**SIGAR Inspection 13-3**

## **GAMBERI AFGHAN NATIONAL ARMY GARRISON: SITE GRADING AND INFRASTRUCTURE MAINTENANCE PROBLEMS PUT FACILITIES AT RISK**

**OCTOBER  
2012**

**Figure 1 - Eroded Channel**

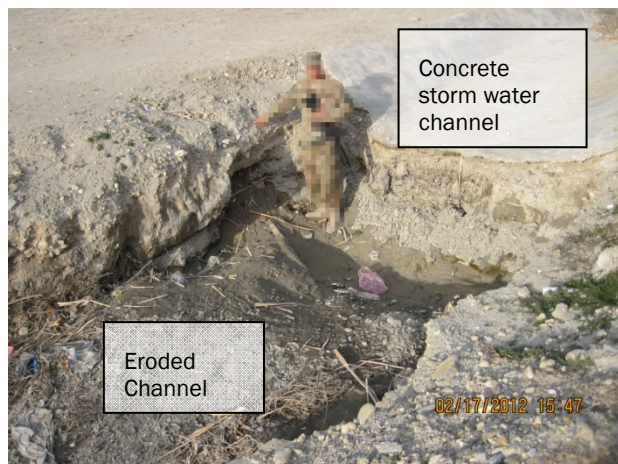
During this inspection, we also observed a channel with erosion of 2,000 mm to 3,000 mm deep (see figure 1) and standing water by the wastewater treatment plant (see figure 2). Due to the amount of erosion, debris, and signs of flooding that we observed, we concluded that USACE had done little to prevent or repair these problems, and its site grading efforts had been ineffective. Poor infrastructure maintenance may have also contributed to garrison flooding, erosion around the storm water channels, and debris blocking water outlets at the perimeter wall and storm drain culverts.

In the southeastern area of the garrison, we noted that the storm water trenches were eroding, which could cause storm water to eventually reach and erode one of the major roads on the garrison. We also observed deep ruts and standing water on other roads. Adding gravel to low lying roads where flooding regularly occurs or applying similar mitigating procedures, would help to drain these areas more quickly.

1. Repair damaged storm water facilities by repairing eroding ditches and removing sediment and debris on roads, in ditches, and in perimeter wall outlets throughout the garrison.
2. Implement mitigating flood control measures, such as adding gravel to low lying roads where flooding regularly occurs to drain these areas more quickly.
3. Establish and follow a program to maintain the storm water drainage system and ensure that timely repairs are made to correct the deficiencies that we identified.
4. Conduct a detailed structural analysis and design review of the culvert design package and take appropriate actions to correct any deficiencies identified.

Figure I - Site Plan Showing Approximate Inspection Locations and Other Information

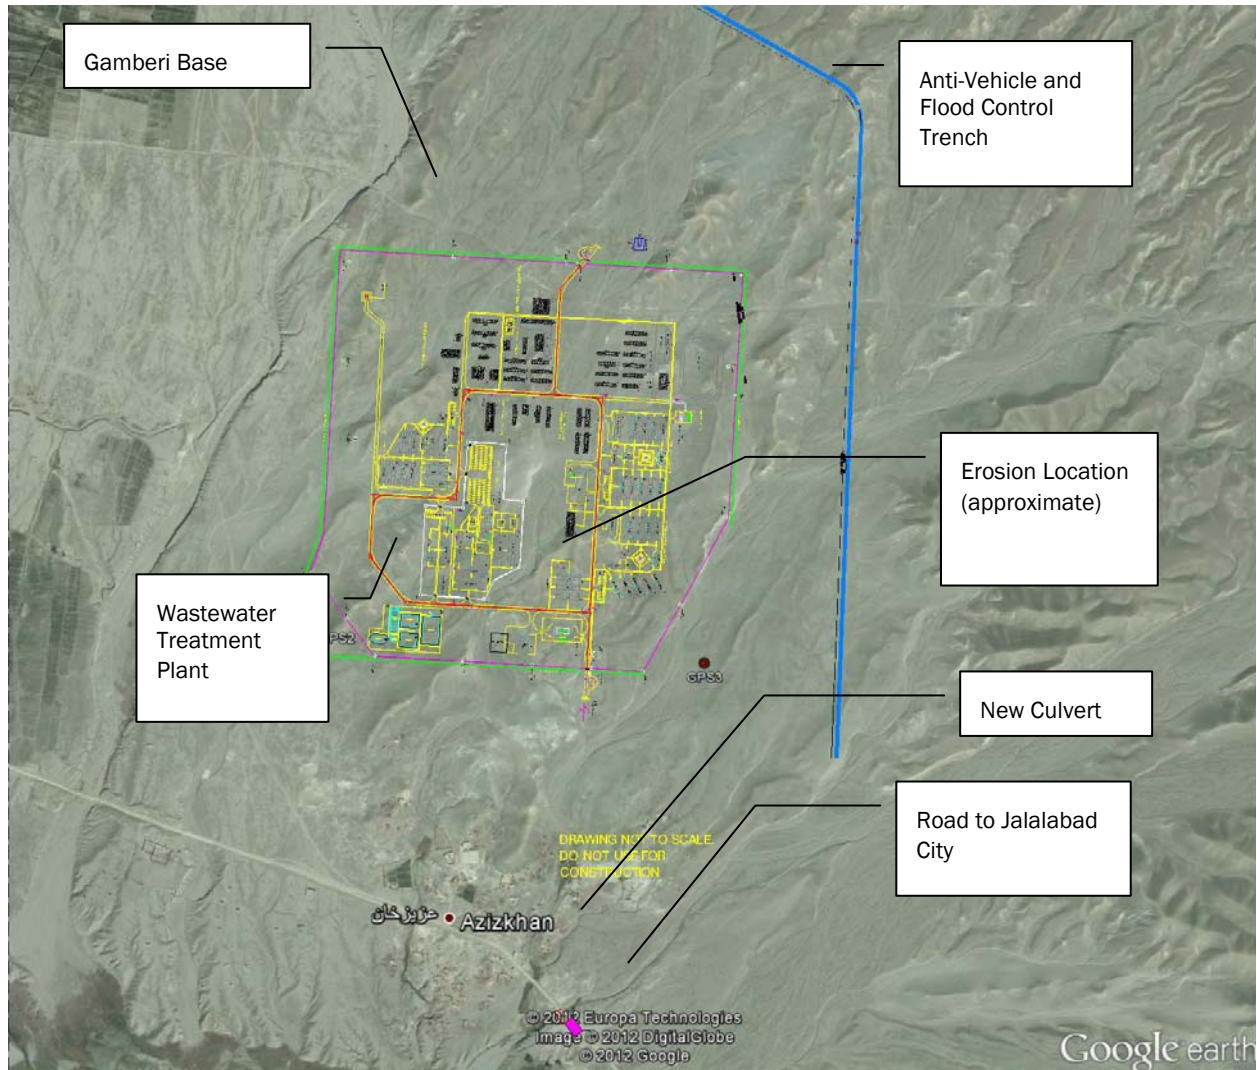
In April 2010, we reported that, although the ANA garrison at Gamberi generally appeared to be well built, several issues needed to be addressed, including poor flood control measures, inadequate grading, a deteriorating bridge, and security at the weapons training range.<sup>4</sup> For example, we noted that the poor grading at the construction site could result in the accumulation of water around buildings and, if not addressed, could lead to flooding after a significant rainfall. We also reported that the deck of the deteriorating bridge could collapse under the weight of armored vehicles and construction traffic. We recommended that USACE take action to (1) mitigate silt accumulation in the anti-vehicle and flood control trench,<sup>5</sup> (2) ensure that the site was properly graded, (3) repair the bridge near the main entrance of the garrison,<sup>6</sup> and (4) secure the weapons training range.<sup>7</sup> Although our 2012 inspection primarily focused on actions taken to address our open recommendation on site grading, we also inspected the new culvert being constructed to replace the deteriorating bridge. Appendix I contains more detail on our scope and methodology, and appendix II contains a site plan showing approximate inspection locations and other information.
